ADDENDUM NO. 2

DATE: May 20, 2025
FROM: City of Grand Junction Purchasing Division
TO: All Offerors
RE: Sanitary Sewer Cured-In-Place-Piping Project IFB-5667-25-DD

18" WATERLINE 4th Ave. & 9th St. to 12th St. & Ute Ave.	SHEET NO. 11
12th St. AT D&RGWRR TRACKS	OF 18
CONSTRUCTION PLAN AND PROFILE	FILE NO.

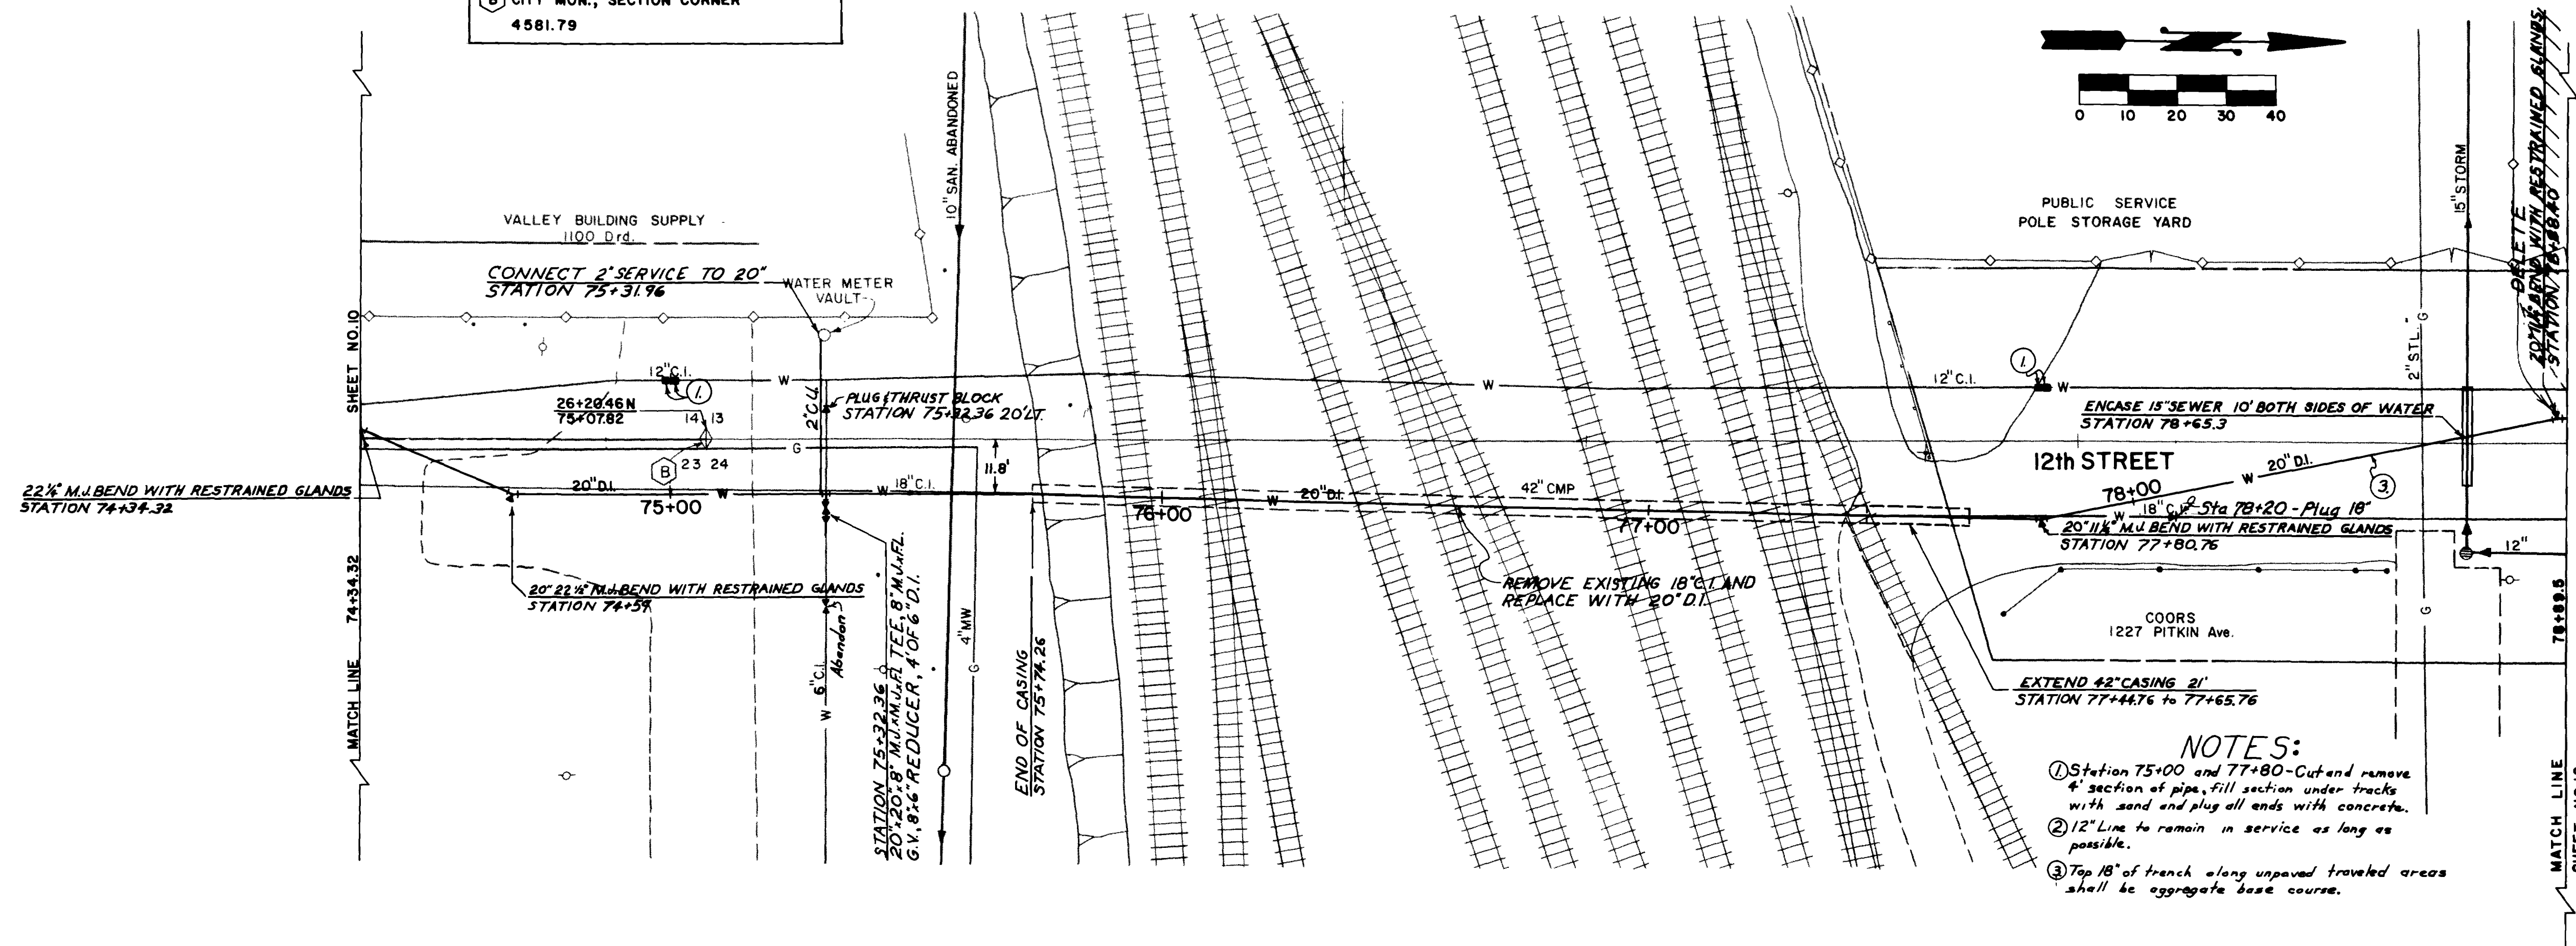
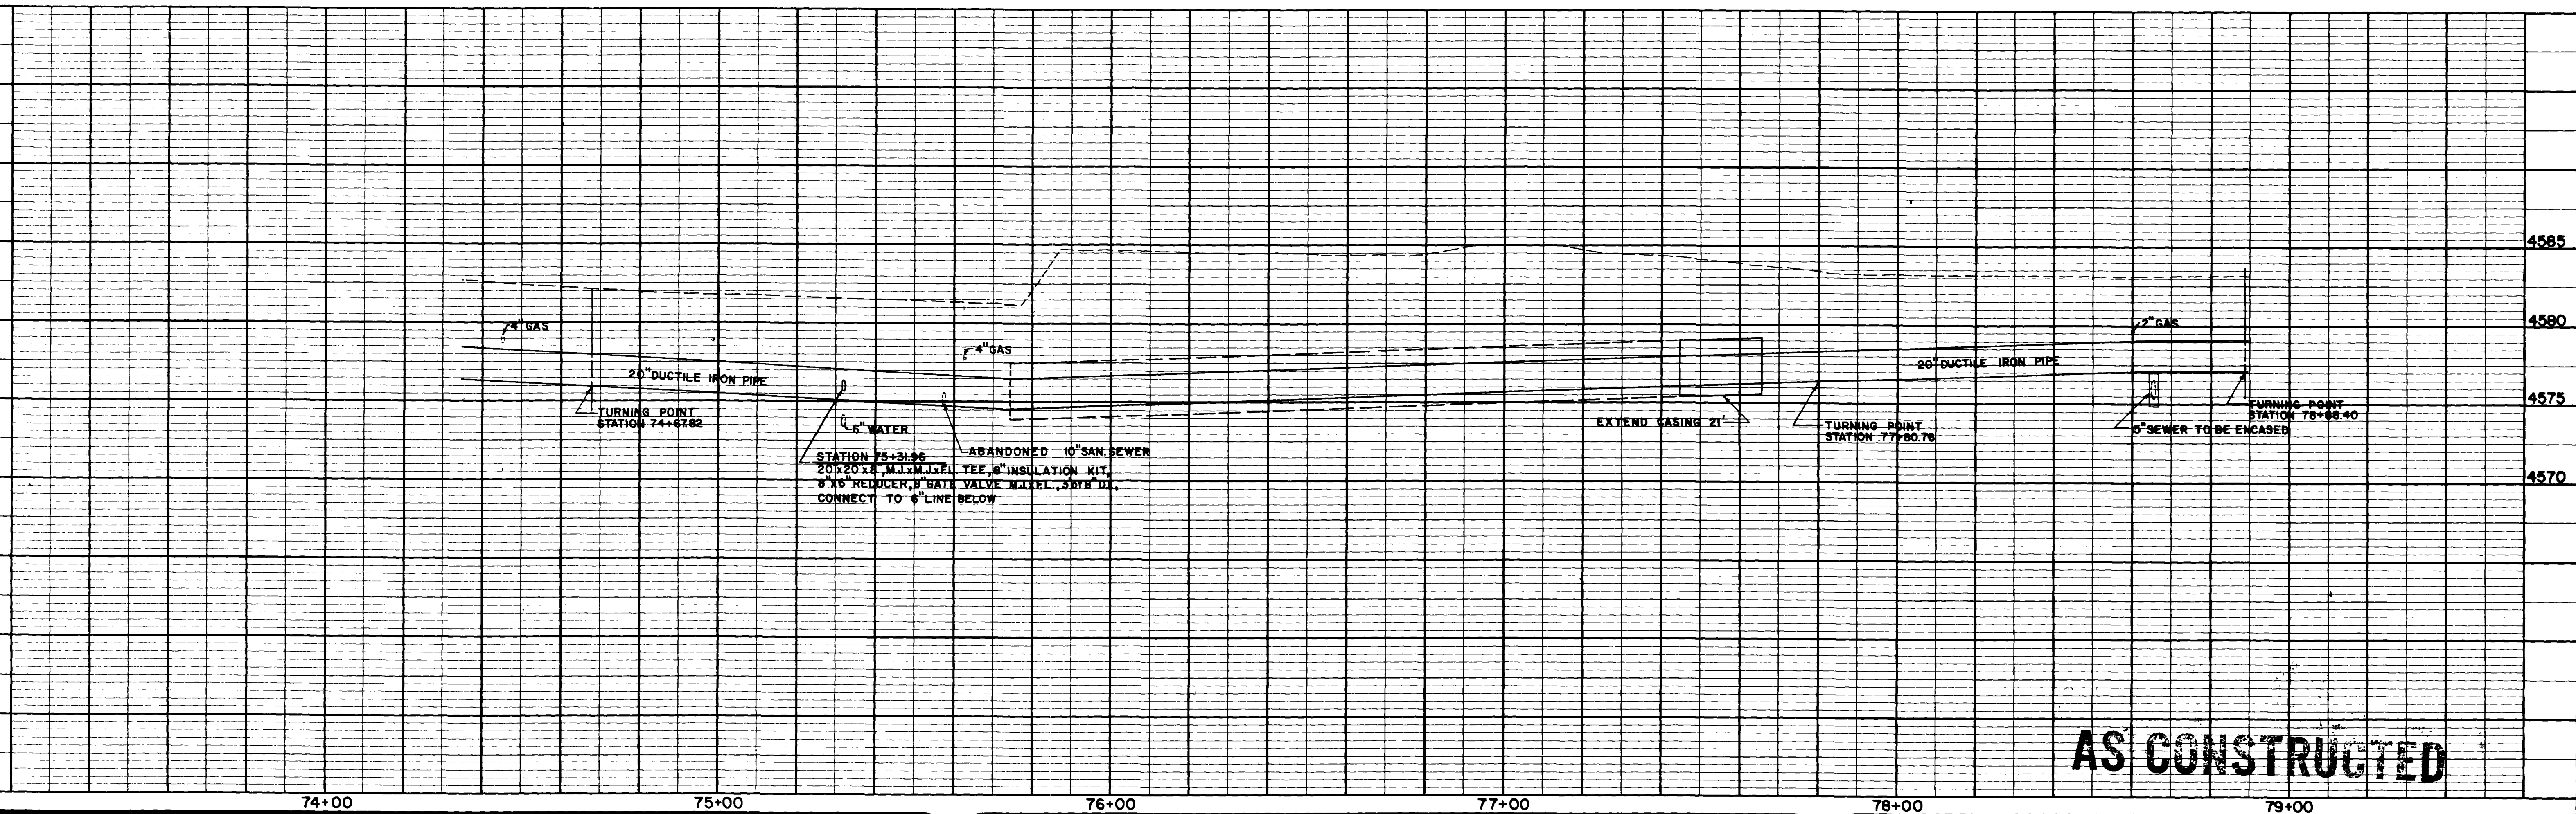
8. Question: Sheet C5.0 of the plan set does not include a profile of the water line. Does the City have a profile? We need to know the elevations at each end of the pipe. We also need to know if the line has any bends in the pipe.

9. Question: Is the existing water line inside a carrier casing under the RR tracks, or is it a stand-alone pipe under the tracks?

Answer: The depth of the water main is called out on sheet C5.0 as 5-feet (top of pipe). This depth is based on City measurements at the valves shown on both sides of the railroad on sheet C5.0. As-built drawings are provided for reference. The as-builts do not show any bends within the 42-inch CMP casing pipe. As-builts are attached for reference.

Answer: In a casing pipe.

Answer: Existing Ø20" ductile iron water pipe is inside a Ø42" CMP
